References: (a) License No. DPR-36 (Docket No. 50-309)
(b) USNRC Letter to MYAPCo dated August 17, 1984
Maine Yankee Reactor Coolant Pump Trip Review

Subject: Response to Questions Regarding Reactor Coolant Pump Trip

RESPONSE TO NRC QUESTIONS REGARDING
MAINE YANKEE REACTOR COOLANT PUMP TRIP STRATEGY

FIGURE 1 RCS Subcooling for SGTR at Maine Yankee

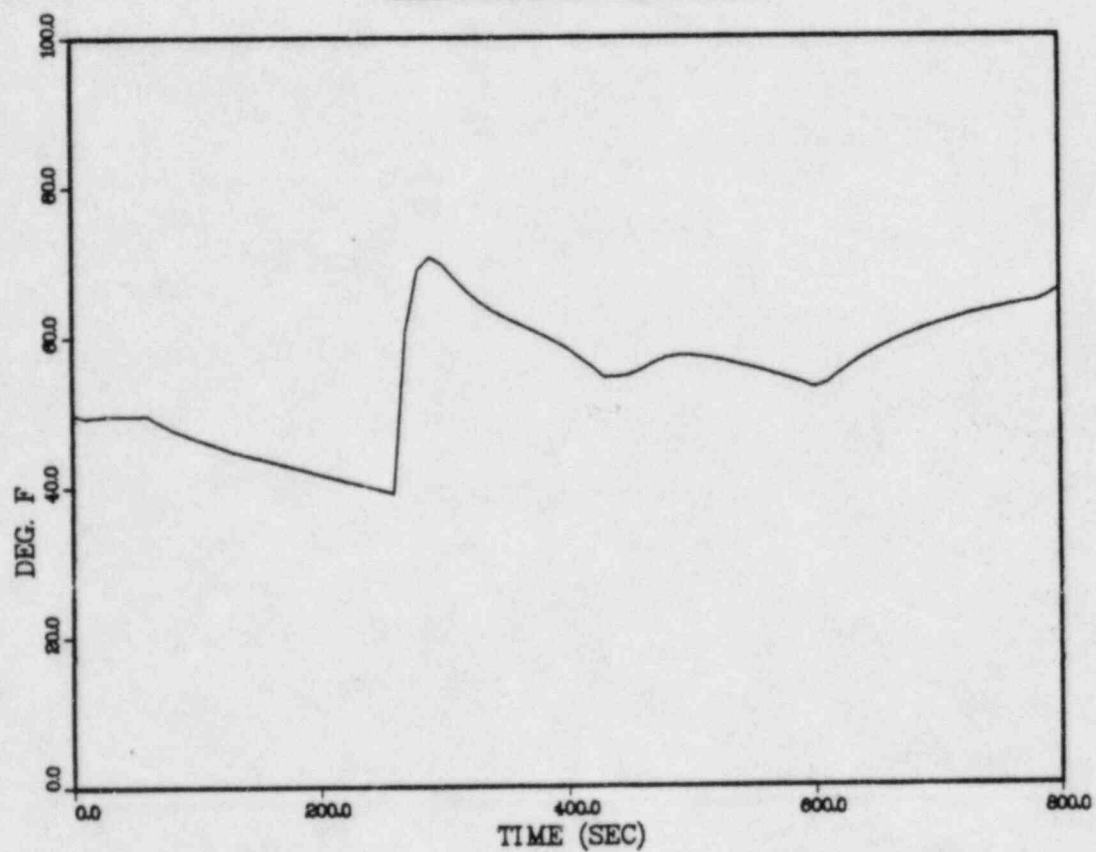
- Q1. Assure that RCP trip will not occur for Steam Generator Tube Ruptures (SGTRs) up to and including the design-basis SGTR?
- R1. The design basis SGTR assumption of a double-ended guillotine break of one U-tube at the tube sheet elevation on the side of the primary fluid outlet has been analyzed. The analysis, initiated at 102 percent power and carried out with the reactor coolant pumps in operation throughout the event, shows that the primary system coolant subcooling margin remains above 39°F (Figure 1). Therefore, RCP trip will not occur for these ruptures when operators are instructed to trip the pumps on the 25 F subcooling monitor alarm.

- Q2. Assure that symptoms and signals differentiate between LOCAs and other transients?
- R2. Vendor analyses of credible events for the assessment of alternate RCP trip criteria (Reference 2) show that, except for the SGTR, the Reactor Coolant System subcooling margin will increase during the non-LOCA transients of concern, as shown in Figure 2 from Reference 2.

Figure 1 shows the behavior of the Reactor Coolant system subcooling for our SGTR analysis discussed in R1.

It follows from these results that for credible non-LOCA events the subcooling margin remains above 39°F.

FIGURE 3 Containment Overpressurization Due to Rupture of 1-Inch Instrument Tap on the Steam Generator

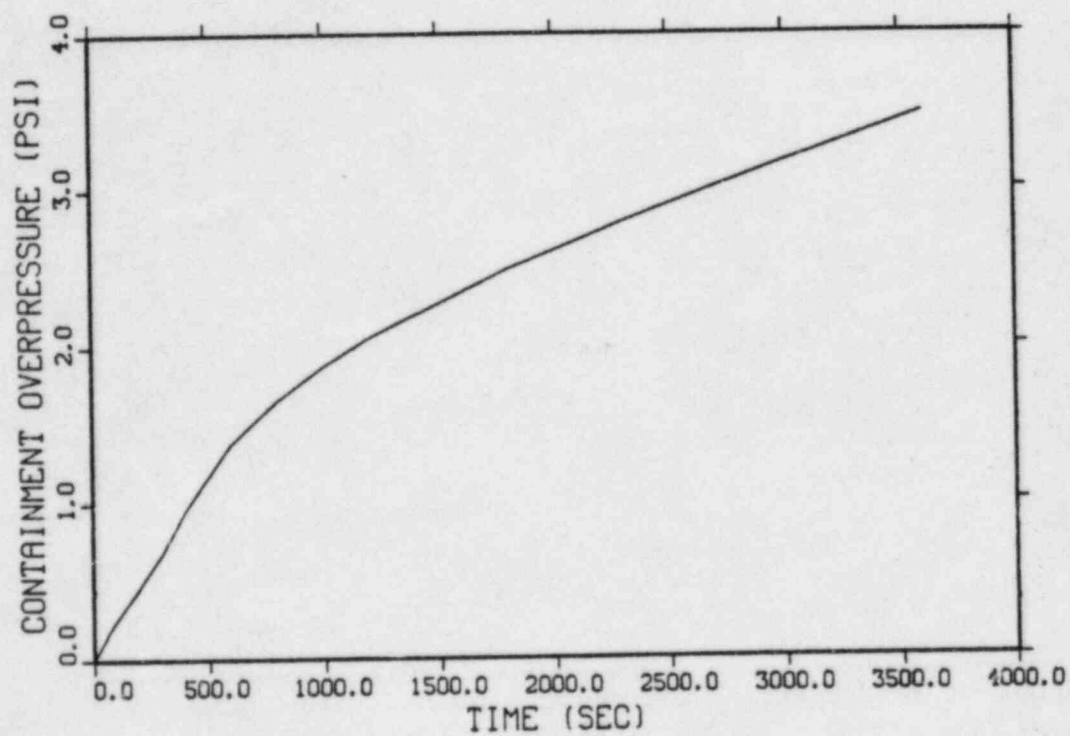
- Q7. Assure that containment isolation will not cause problems if it occurs for non-LOCA transients and accidents?
- R7. It is possible to postulate non-LOCA accident conditions which would lead to containment isolation. However, the objective of the proposed RCP trip strategy is to establish reasonable assurance of continued pump operation during non-LOCA events. In this context, a "credible", non-LOCA accident that could lead to containment isolation would be a stuck open Steam Generator Safety Relief Valve (SGSRV), as assumed in the study of Reference 2. However, the Maine Yankee SGSRVs are not located inside the containment. Hence, it is felt that Maine Yankee is not subject to "credible" (e.g., stuck open SGSRVs) non-LOCA events resulting in containment pressurization. Nevertheless, a break in one of the smaller lines connected to the steam generator was postulated. The containment pressurization rate for an event of this type can be best estimated by assuming a break in the instrument tap connected to the steam generator head. The continuous blowdown of dry, saturated steam at normal steam generator operating pressure, through a complete severance of the tap was analyzed with the CONTEMP-LT code. It was found that it would take more than one hour to overpressurize the containment by 3.75 psi, the amount required for isolation (Figure 3). In this large time frame, operator action would have been taken to arrest the pressurization and to avoid any potential problems due to containment isolation.
